MEETING:	PLANNING COMMITTEE
DATE:	7 April 2017
TITLE OF REPORT:	<p>163996 - CHANGE OF USE TO HIGH QUALITY PUBLIC OPEN SPACE AND A LANDMARK PUBLIC ART FEATURE. APPLICATION FOR A SKYLON TOWER, A 46M HIGH, VERTICAL, CORTEN STEEL LANDMARK FEATURE LOCATED WITHIN THE HEART OF SKYLON PARK, HEREFORD ENTERPRISE ZONE. AT JUNCTION OF THE STRAIGHT MILE AND B4399, ROTHERWAS, HEREFORD, HR2 6JL</p> <p>For: Mr Pearce per Mr Mark Martin, 5 The Triangle, Wildwood Drive, Worcester, WR5 2QX</p>
WEBSITE LINK:	https://www.herefordshire.gov.uk/info/200142/planning_services/planning_application_search/details?id=163996&search=163996
Reason Application submitted to Committee – Council Land

Date Received: 13 December 2016 Ward: Dinedor Hill Grid Ref: 353327,237847

Figure 2: Site layout

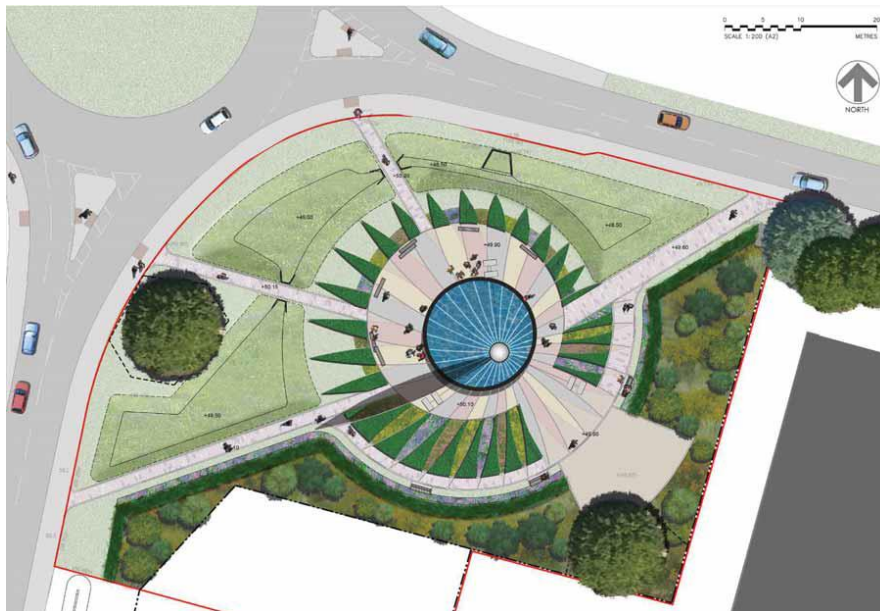
- I note that within the hard landscaping plans a variety of colours are incorporated into the paved area; I would recommend the use of a subtle colour palette in this instance in order to avoid detracting from the sculptural feature. The report states that the colours have been selected to complement the wider masterplan of the Skylon Park it would therefore be helpful to see a copy of the masterplan to understand how the design relates to the wider park.

- The plans indicate the retention of a field maple on site, the RPA of which would need to be shown on the landscaping plans with measures for its protection during the construction phase.

- 6.23 The queries raised by the landscape officer in her comments at 4.8 are addressed via planning conditions. These include the requirement to submit samples of the construction materials for the tower itself and paving. The agent has commented that in selecting materials for the Skylon Tower it was felt that cor-ten steel would be more relevant and appropriate in representing the look and feel of the industrial past of the Hereford site than potential equivalents e.g. stainless steel which has a more polished and reflective quality. Visitors to the site will experience this metal cor-ten finish from the base to approximately the first ten to fifteen metres. At that point the material will change to GRP which is a light weight but similarly strong and low maintenance material. The GRP is non-reflective and its texture can be matched to that of the cor-ten.
